Advance World Limited (New)

2 September 2025

Structural Inspection Report

Observation-01: Stress in the column above normal design limit (Production building).

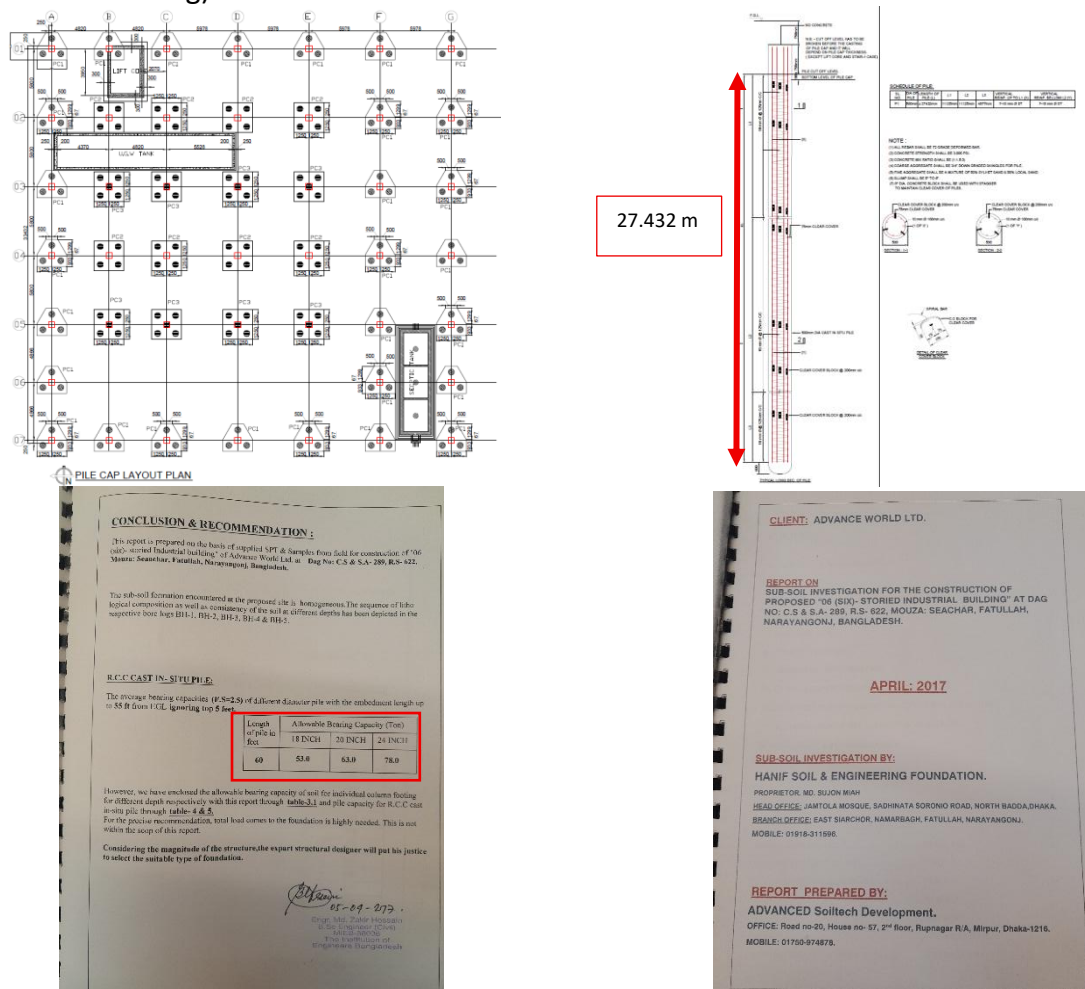
Description: The cursory calculation indicates that columns are stressed above normal design limits under gravity loading at the marked locations, considering floor live load of 3 kPa for the typical floors, 5 kPa for the stairs, 1.5 kPa for the roof, minimum concrete strength based on aggregate type (16.3 MPa), and minimum rebar strength (415 MPa). The building engineer is required to review the design, loads, and column stresses. Take a minimum 4-100mm diameter concrete core for the structural elements (column, beam/slab) to verify the in-situ concrete strength. Produce and actively manage the loading plan according to the floor capacity.

Observation-02: Absence of credible structural drawing and inadequate soil test report.
(Production Building)

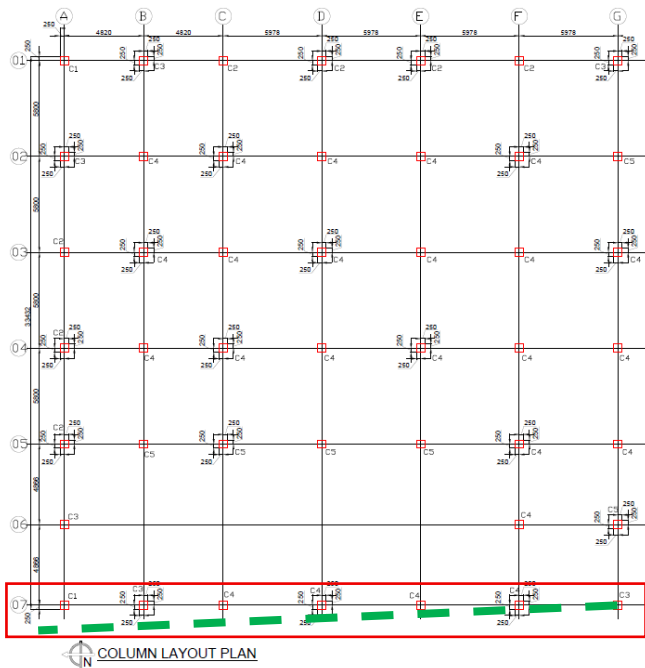
Description: During the inspection, no credible structural drawing was available on-site for the Production Building. A soil investigation report was found prepared by the “Hanif Soil & Engineering Foundation” in April 2017. In the prepared as-built drawing, the pile length was shown as 27.432 m with a pile diameter of 500 mm. However, in the provided soil test report indicated data for only 18.29 m pile length. The allowable pile capacity for 18.29 m (500 mm Dia) was reported as 63.3 tons (F.S: 2.5), which appears to represent a lower factor of safety. The building engineer is required to verify the actual pile length by conducting a PIT (Pile Integrity Test), carry out a new soil investigation considering the actual pile length, and review the foundation stresses as part of a Detailed Engineering Assessment (DEA) based on the updated soil and pile information.

Observation-03: Mismatch in as-built drawing (Production Building).

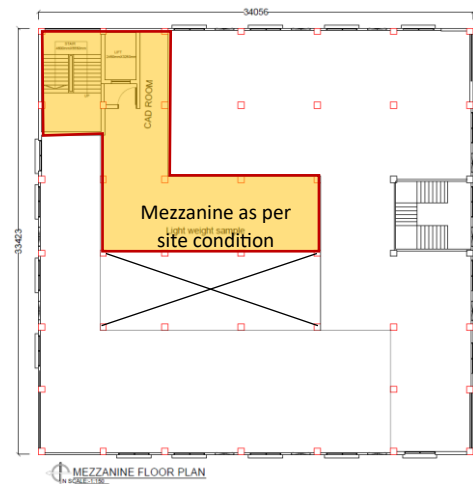
Mismatch in grid dimension (Grid 7 marked in column layout) was found column layout. Grid 7 was found slightly tapered.

Undocumented 2 storied toilet zone (south side) not shown in drawing.

The toilet floor build-up was not shown in the drawing.

Mezzanine floor layout was not matched with onsite condition.

Undocumented O.H.W.T and roof shed not shown in drawing

Description: During inspection, mismatches and lack of information were observed between drawings & existing condition. The building engineer is required to survey the structural components and produce accurate structural drawings.

Observation-04: Lack of design report and permit drawing. (Utility Building)

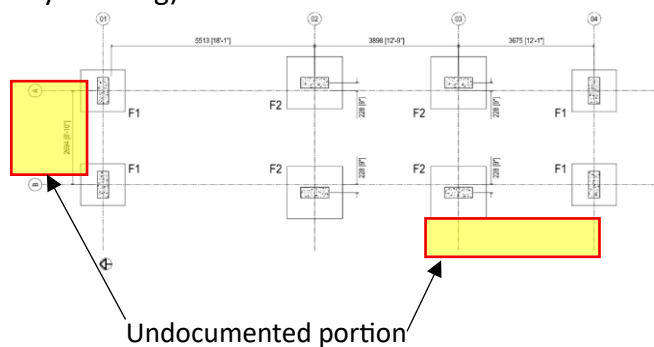
Description: As per BNBC, every building or structure designed shall have its design documents prepared in accordance with the provisions of Section 1.9.1. The design document shall include a design report and a set of structural drawings, which shall be prepared in compliance with section 1.9.1.1 and section 1.9.1.2, part 6 of BNBC. At the time of inspection, only a set of incomplete drawings was available, also no design report & load plan (mezzanine) were available which are required to be prepared in compliance with section 1.9.1.1 (part- 6, BNBC). Also, collect permit drawings from the local authority.
